ENGINE - HP TURBINE ROTOR AND STATOR ASSEMBLY - PROVIDE NEW STAGE 1 HPT SUPPORT ASSEMBLY AND A NEW STAGE 1 HPT VANE ASSEMBLY - CATEGORY CODE 8 - MOD.ENG-72-0147

V2500-ENG-72-0147

SERVICE BULLETIN

Location of Stage 1 HPT Duct Support Assembly
Fig.1

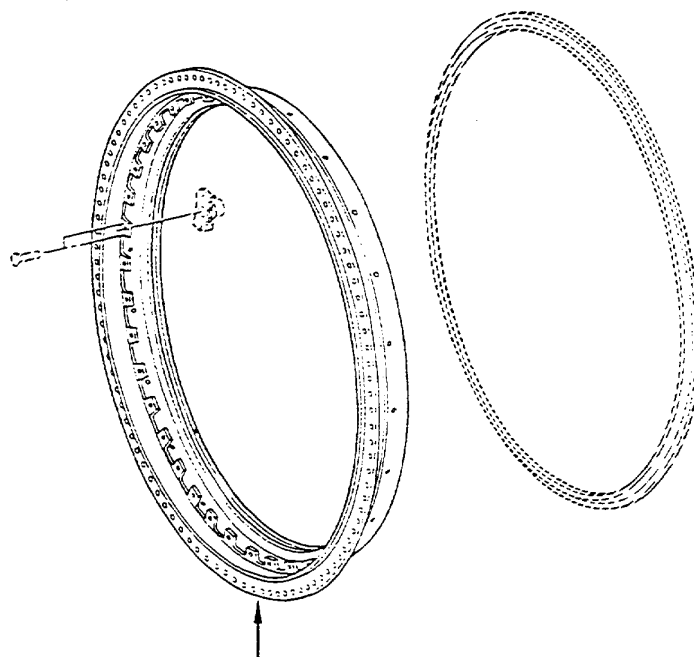
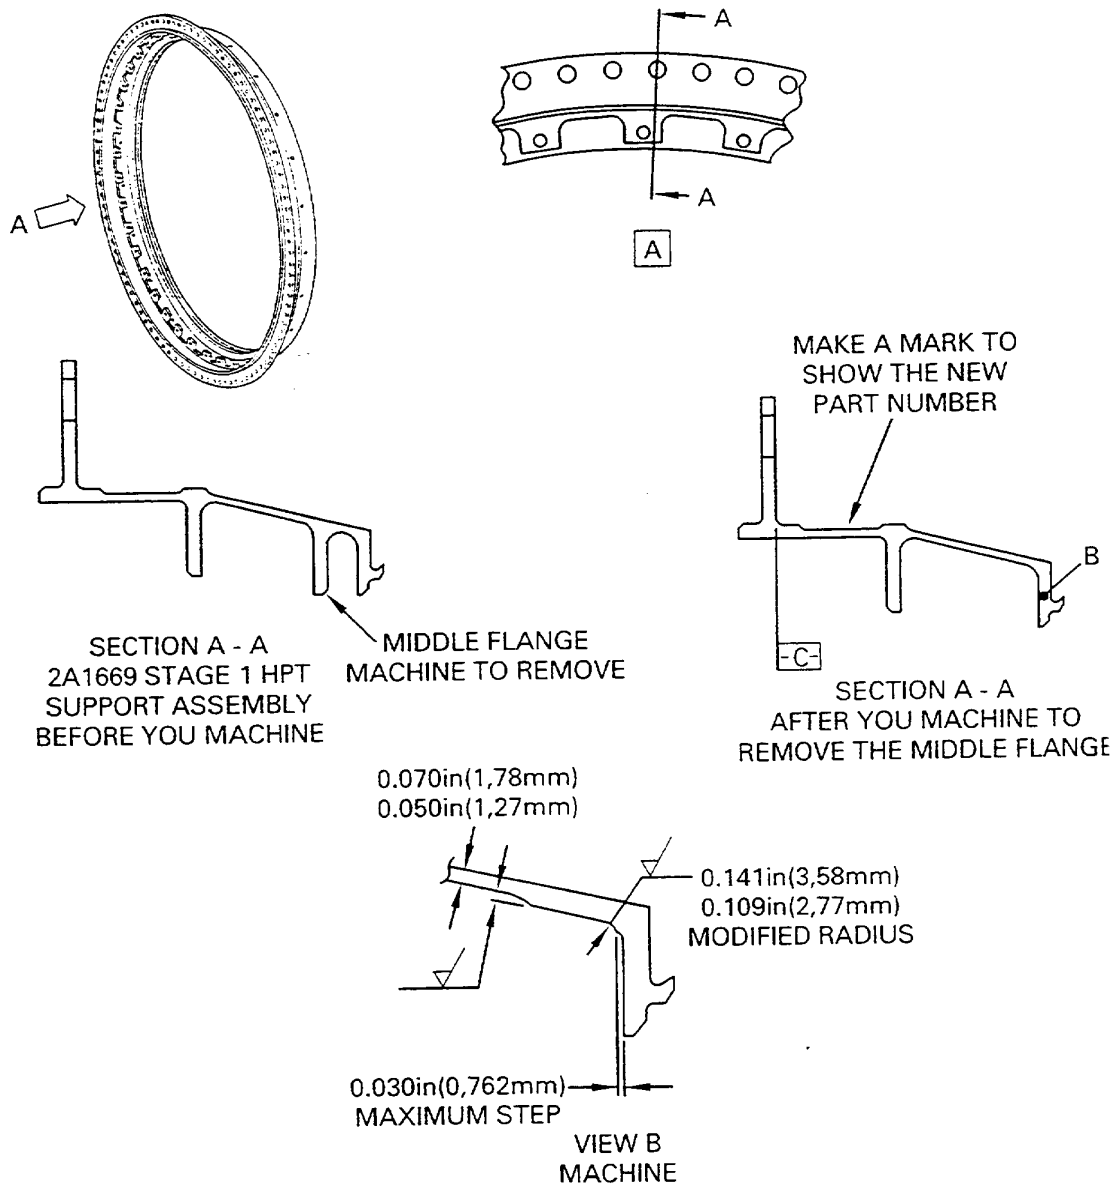
- (1) For V2500-A5 Engines proceed as follows:
- (a) Install the 2A2703 Stage 1 HPT Support Assembly (1 off) by the procedure given in Reference (3), Chapter/Section 72-44-00, Assembly. Refer to Figure 1.

- (a) Install the 2A2703 Stage 1 HPT Support Assembly (1 off) by the procedure given in Reference (4), Chapter/Section 72-44-00, Assembly. Refer to Figure 1.

INSTALL THE 2A2703
STAGE 1 HPT SUPPORT
ASSEMBLY

Modification of Stage 1 HPT Duct Support Assembly
Fig.2 (Sheet 1)

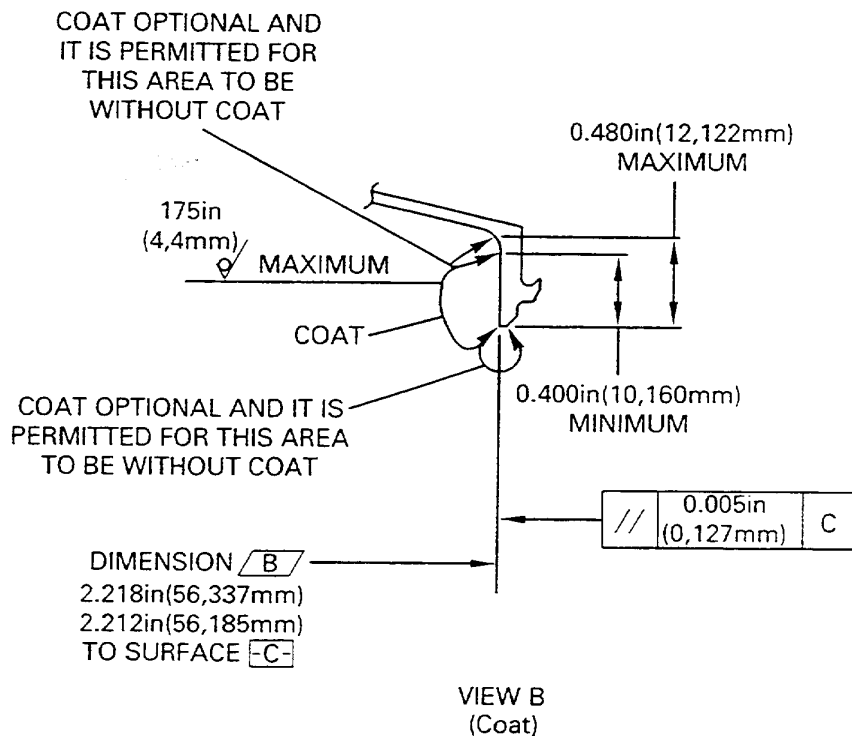
Procedure	Supplementary Information				
(a) Set-up and machine to remove the middle support rail and prepare the front face of the rear flange for coat.	Refer to Figures 1 and 2.				
(b) Coat the front face of the rear flange. Use CoMat 03-077 plasma spray powder. Keep to the dimensions specified.	Refer to Figure 2 for the location of the plasma coat. Use the procedure given in Reference (2), Control No. TASK No. 70-34-03-340-501.				
(d) Mark the new part number adjacent to the old part number. Use the vibration peen method.	<table><tr><td>Old Part No.</td><td>New Part No.</td></tr><tr><td>2A1664</td><td>2A2703</td></tr></table> <p>See Reference (2), Control No./TASK No. 70-09-00-400-501. Refer to Figure 2.</p>	Old Part No.	New Part No.	2A1664	2A2703
Old Part No.	New Part No.				
2A1664	2A2703

NOTE: IN A FREE STATE SURFACE -C-

IS	<div style="border: 1px solid black; padding: 2px; display: inline-block;"><div style="width: 10px; height: 10px; border-bottom: 1px solid black; margin-bottom: 2px;"></div>0.010in (0,254mm)</div>
----	--

Location of Stage 1 HPT Vane Assembly
Fig.3

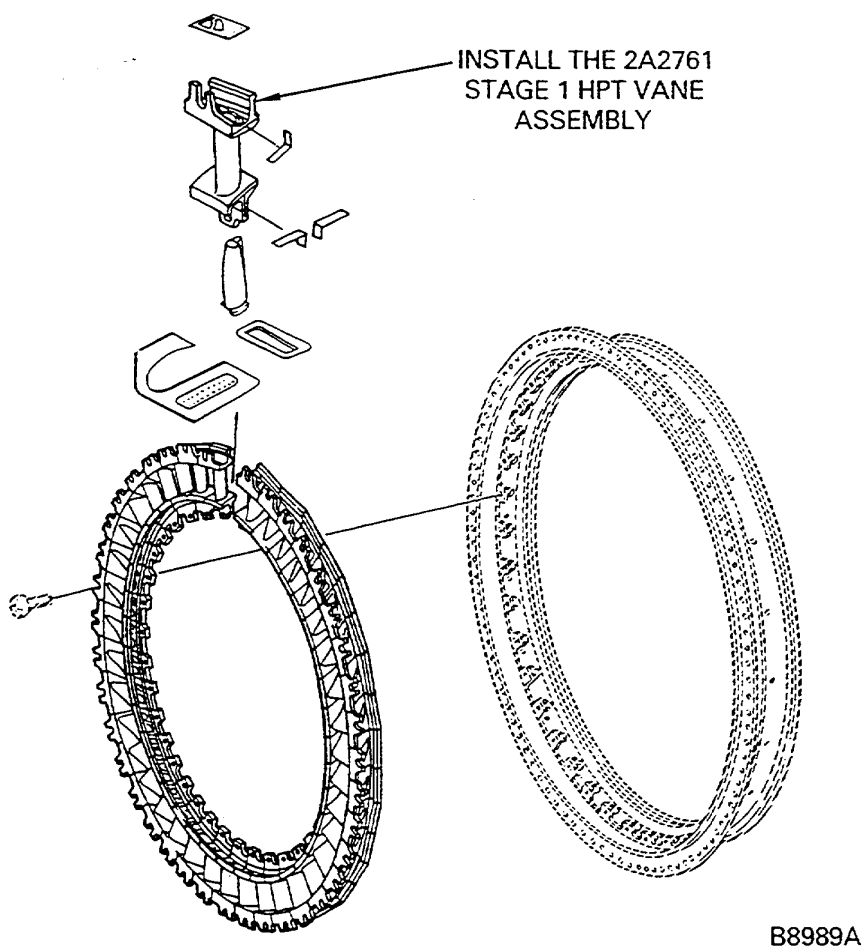
- (b) Install the 2A2761 Stage 1 HPT Vanes (40 off). Use the procedure given in Reference (3), Chapter/Section 72-44-00, Assembly. Refer to Figure 3.

- (b) Install the 2A2761 Stage 1 HPT Vanes (40 off). Use the procedure given in Reference (4), Chapter/Section 72-44-00, Assembly. Refer to Figure 3.
